February 9, 2018

**Re:** Responses to Comments of Cell 17 Draft Substantial Modification Application  
Pasco County – Solid Waste  
Facility Name: Enterprise Road Class III Recycling and Disposal  
Facility Site ID: 87895  
DEP Application Nos.: 177982-023-SC/T3 and 177982-024-SO/T3

Thank you for your review of the above-referenced permit modification draft for the Enterprise Road Class III Recycling and Disposal Facility. The following information is provided in response to the FDEP's draft comments email dated October 17, 2017. Information is provided in the order requested in the referenced correspondence. In each case, the Department's request is stated in italics with the response immediately following in **bold**.

FIGURE 1  
SITE MONITORING NETWORK

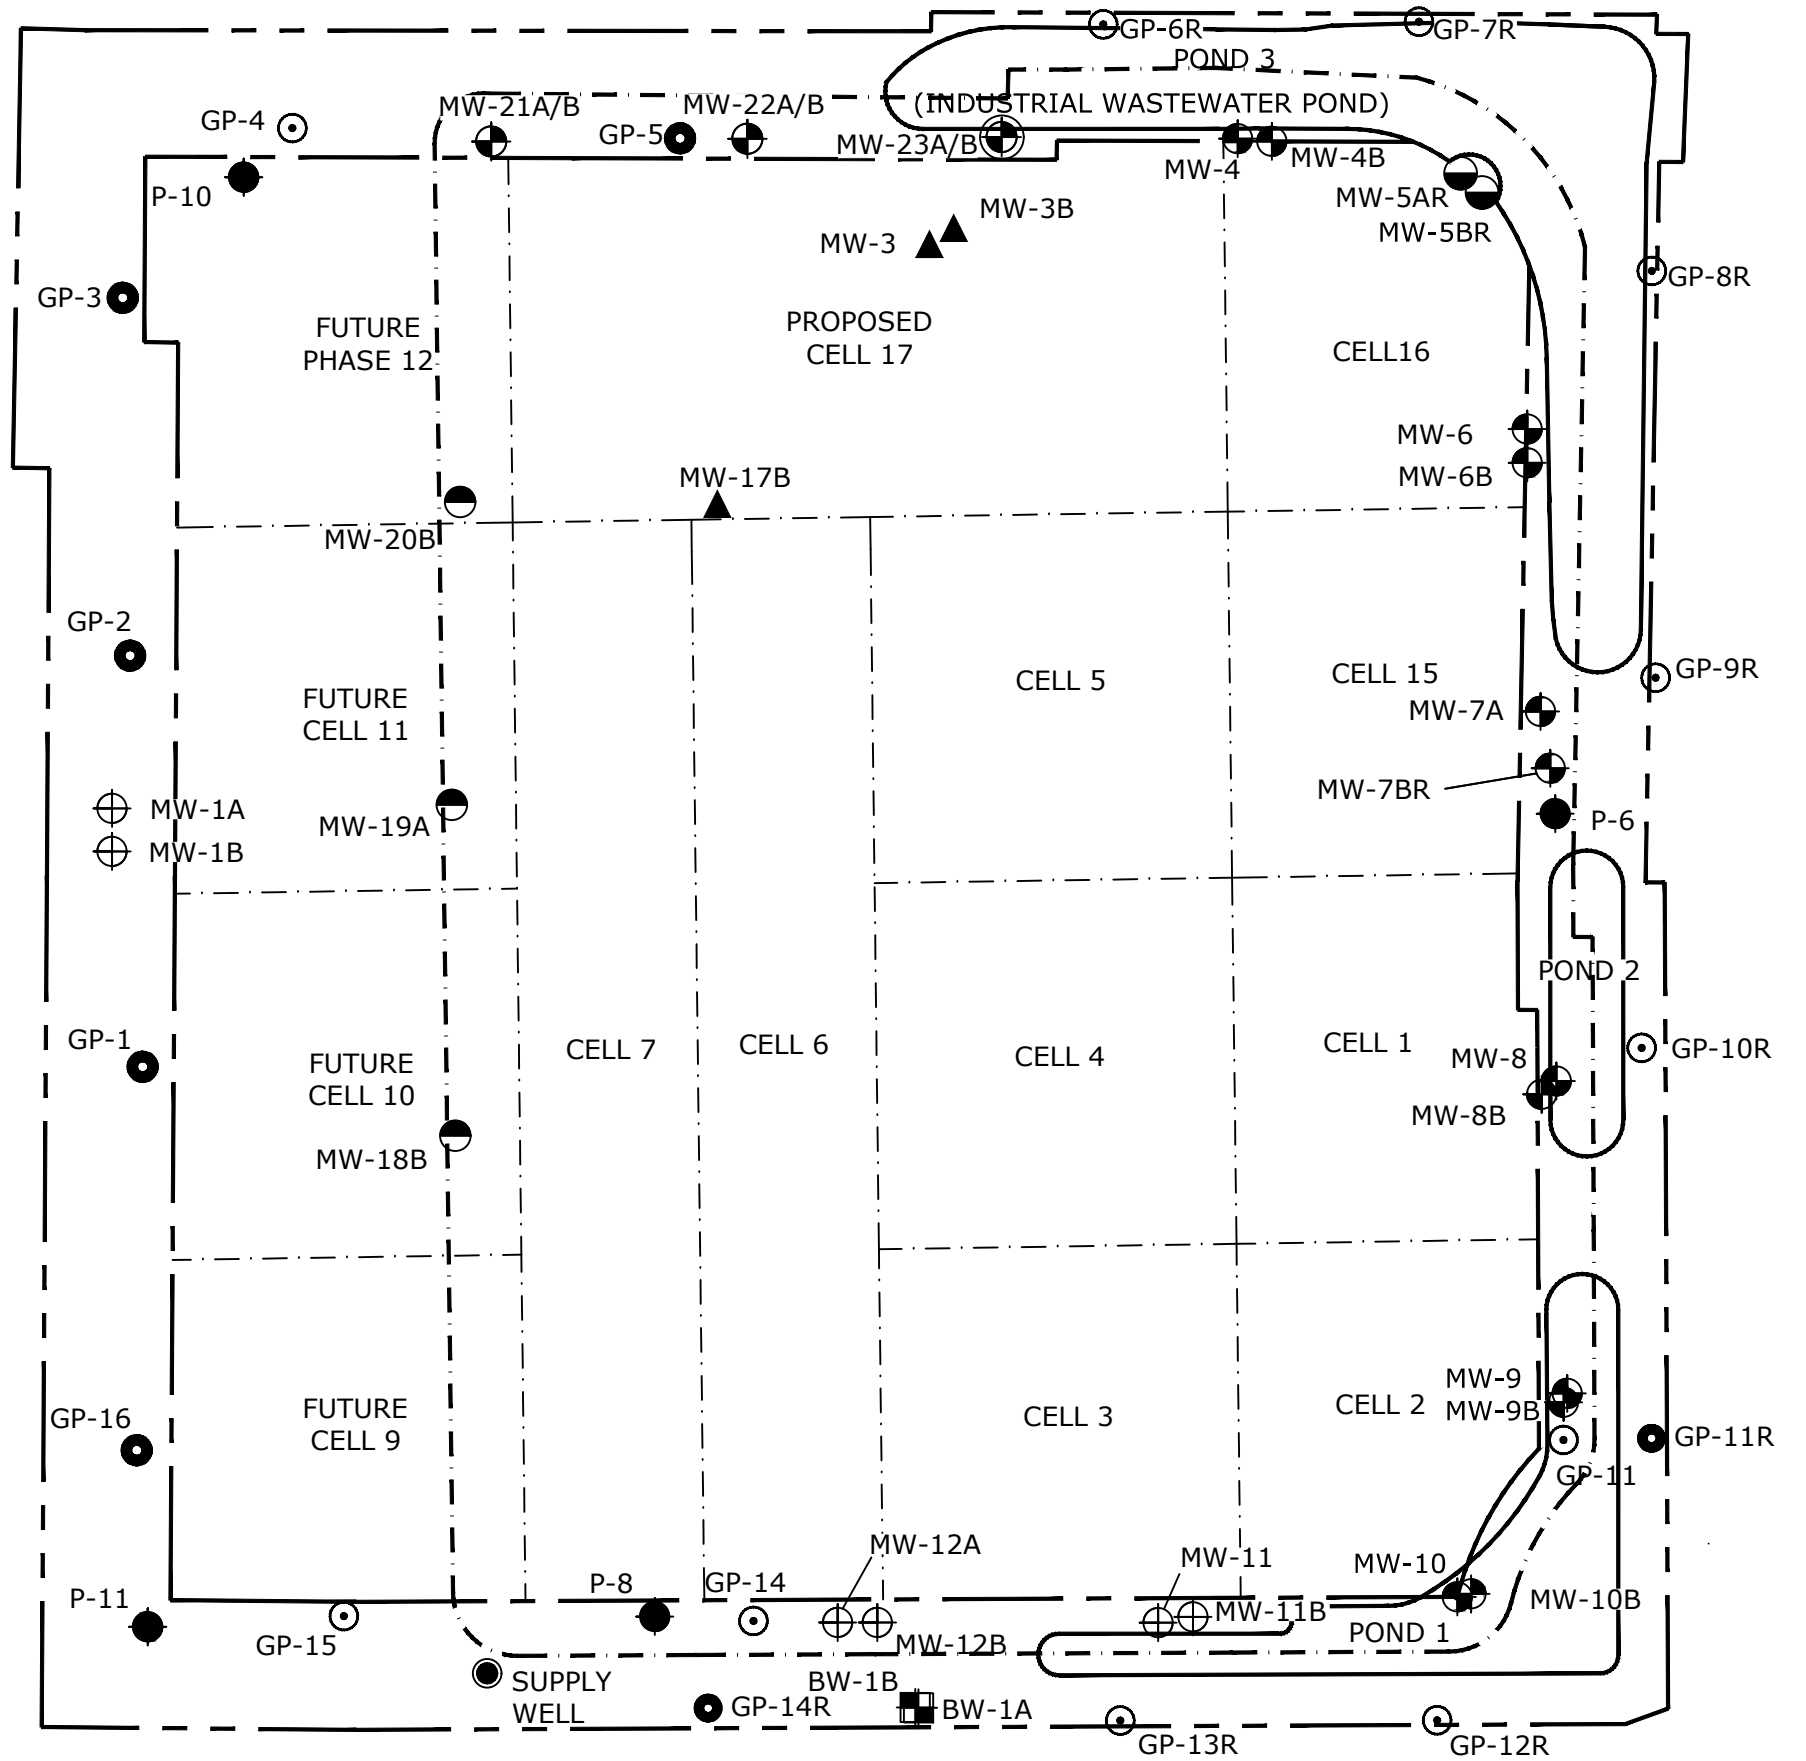
*Comment 13: Figure 1 – Site Monitoring Network: This figure should be modified, as appropriate, based on your response to comments on the proposed WQMP.*

**RESPONSE 13: Figure 1 – Site Monitoring Network has been revised accordingly.**

**REVISED  
FIGURE  
S-1**

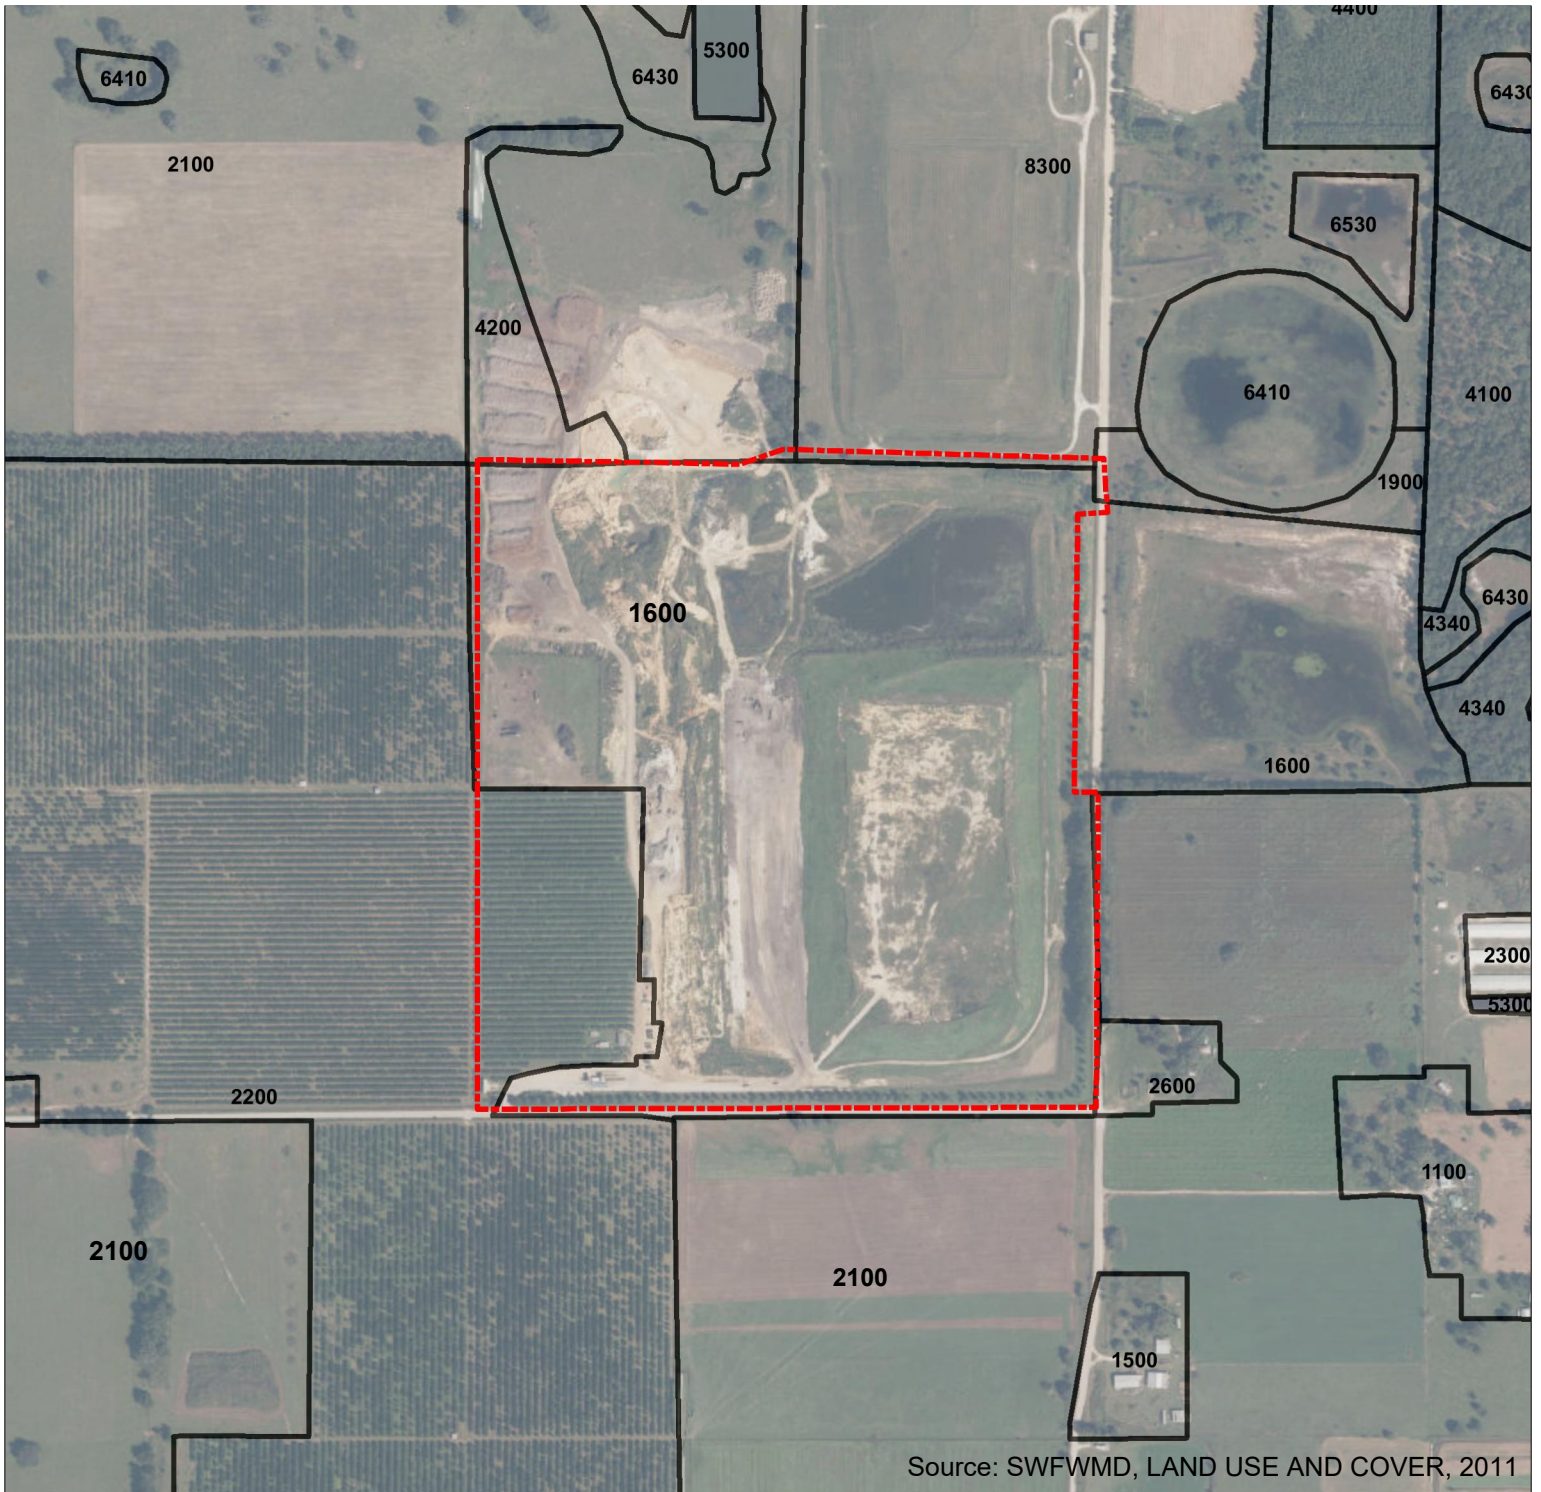
b. *Referenced revised Figure 5 does not appear to have been provided.*

**RESPONSE 25:** a. Figure 3-2A in Appendix 3-C has been updated and revised.  
b. The potable well inventory was incorrectly referenced as Figure 5 in the Engineering Report. The correctly referenced potable well inventory is Figure S-1. Figure S-1 has been updated and revised.

PROJECT NO.:  
02000-217-17  
SCALE:  
AS SHOWN  
DATE:  
AUGUST 2017  
DRAWING:  
C0.04

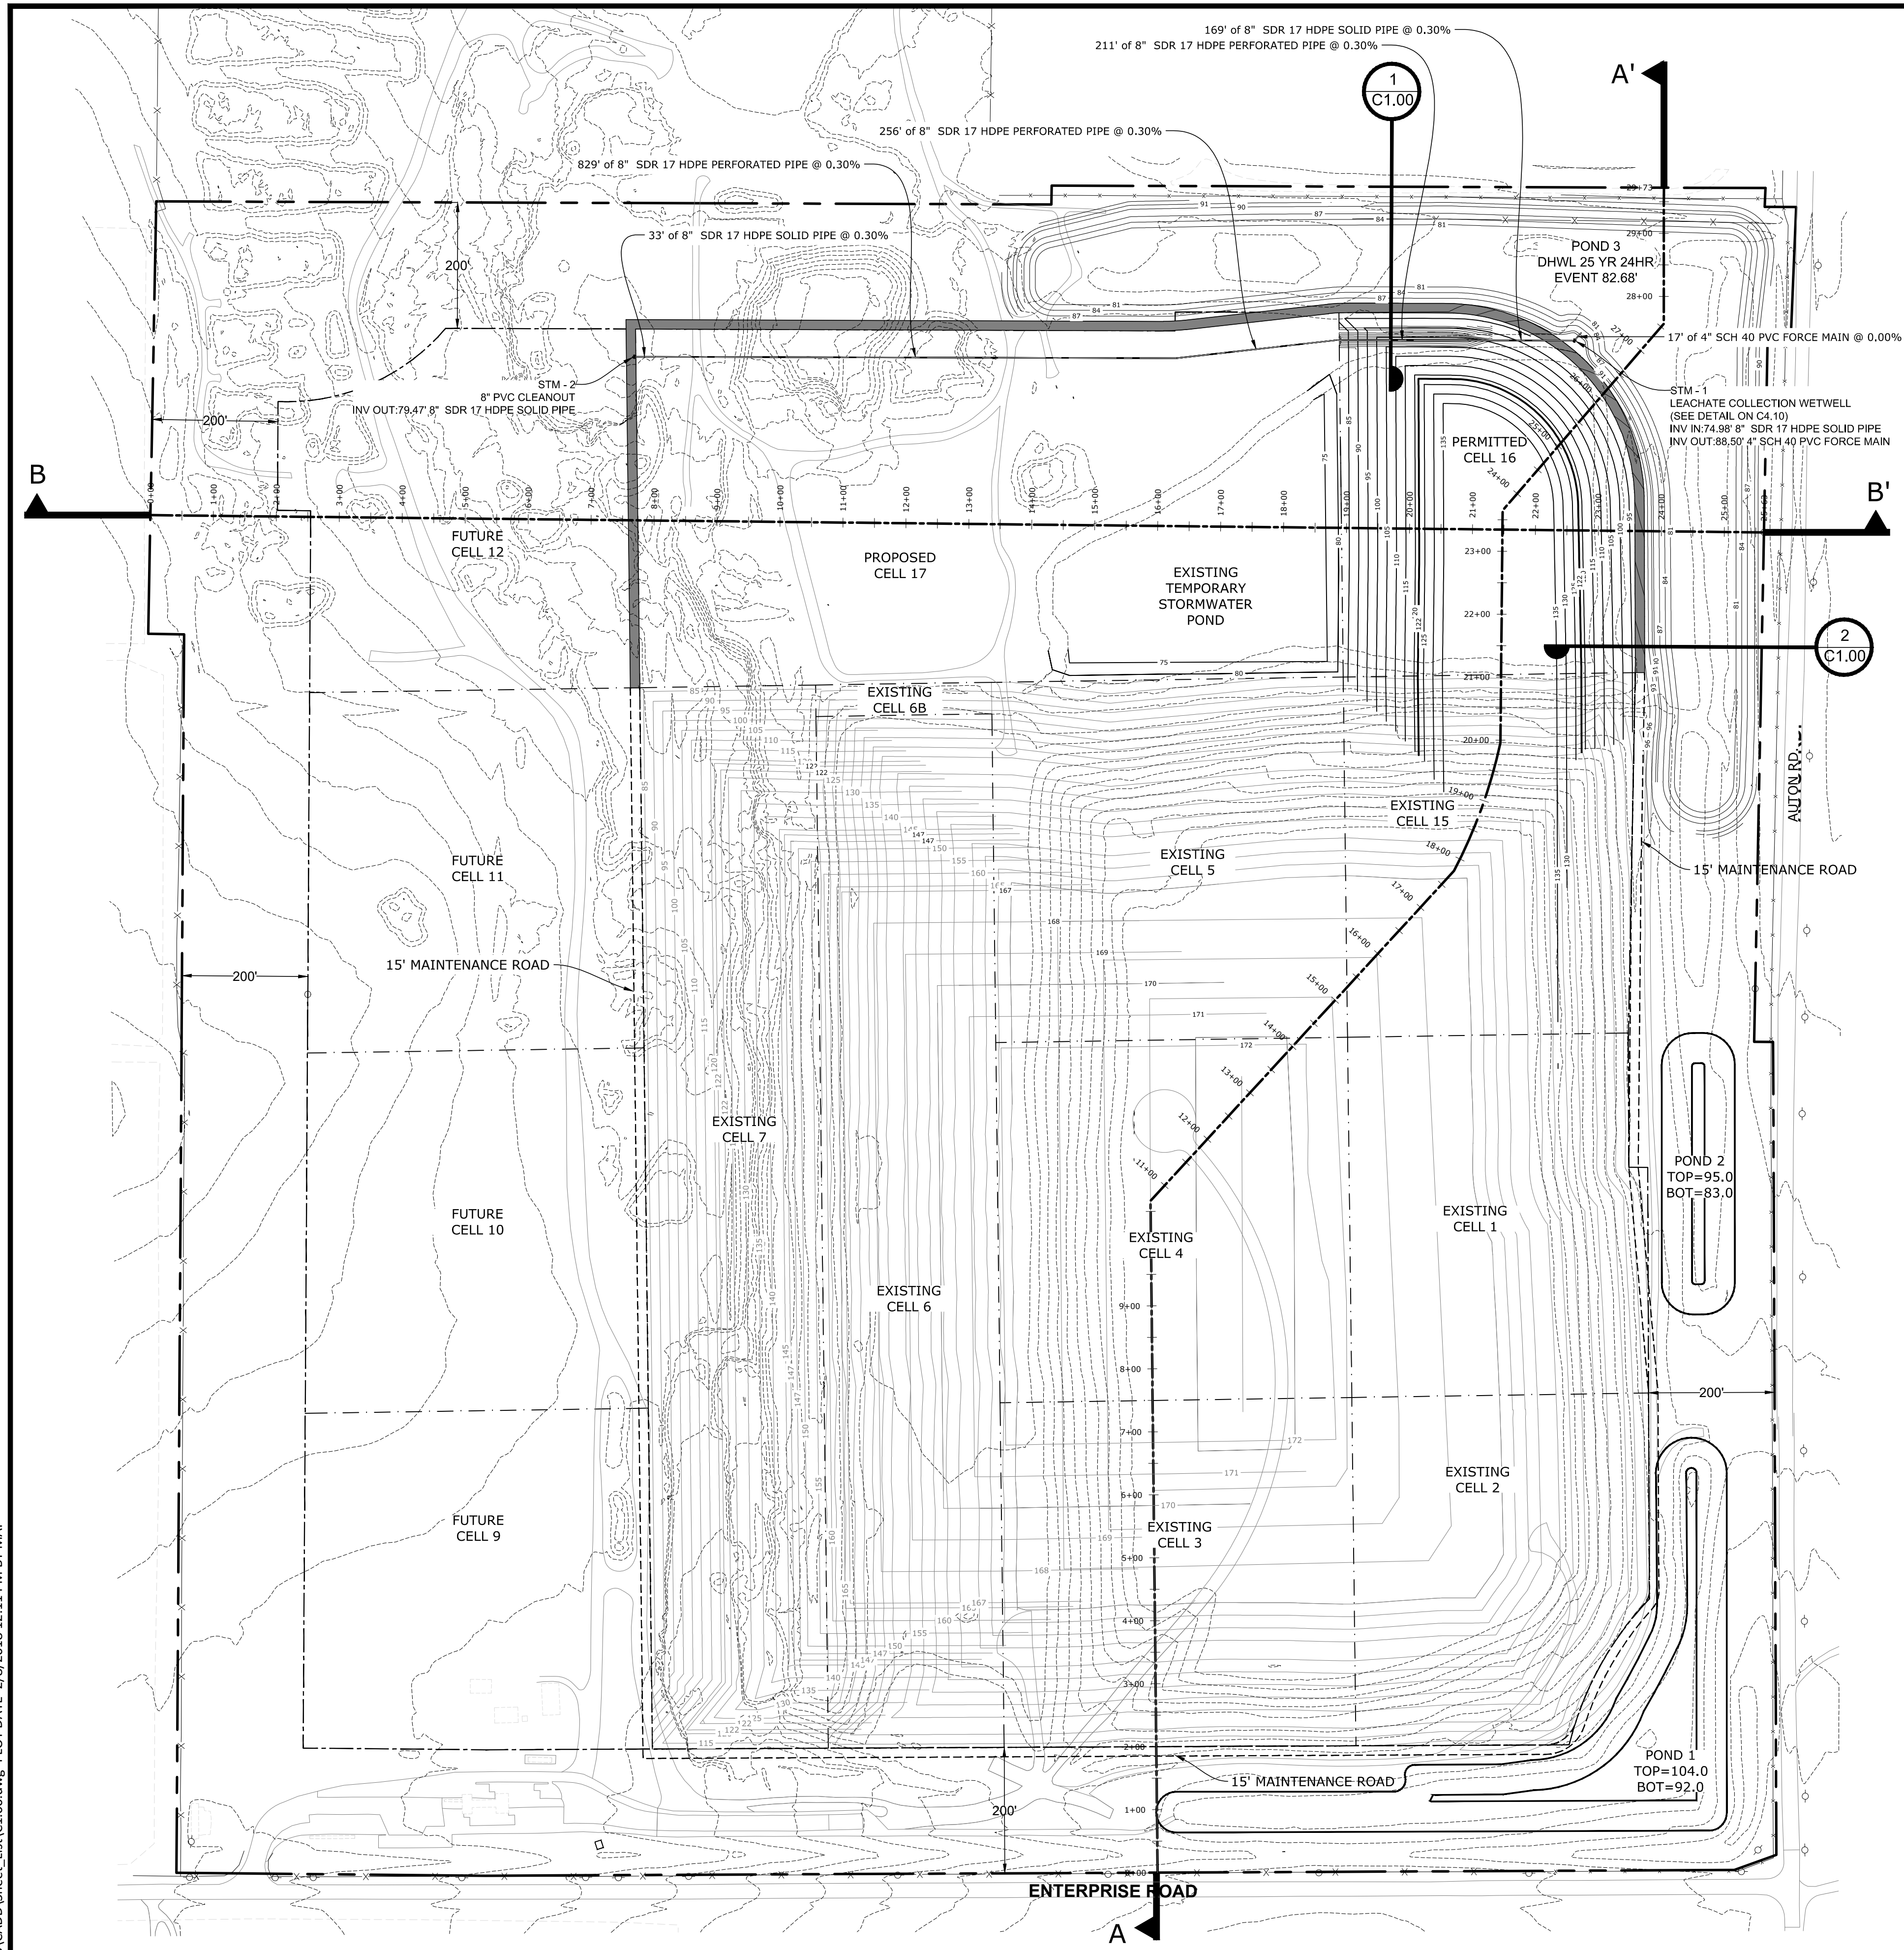
*Comment 44: Drawing C0.04:*

- a. The Plan Set has been revised to include leachate lift station details.**
- b. Drawing C0.04 has been revised to show the Cell 17 temporary diversion berm.**
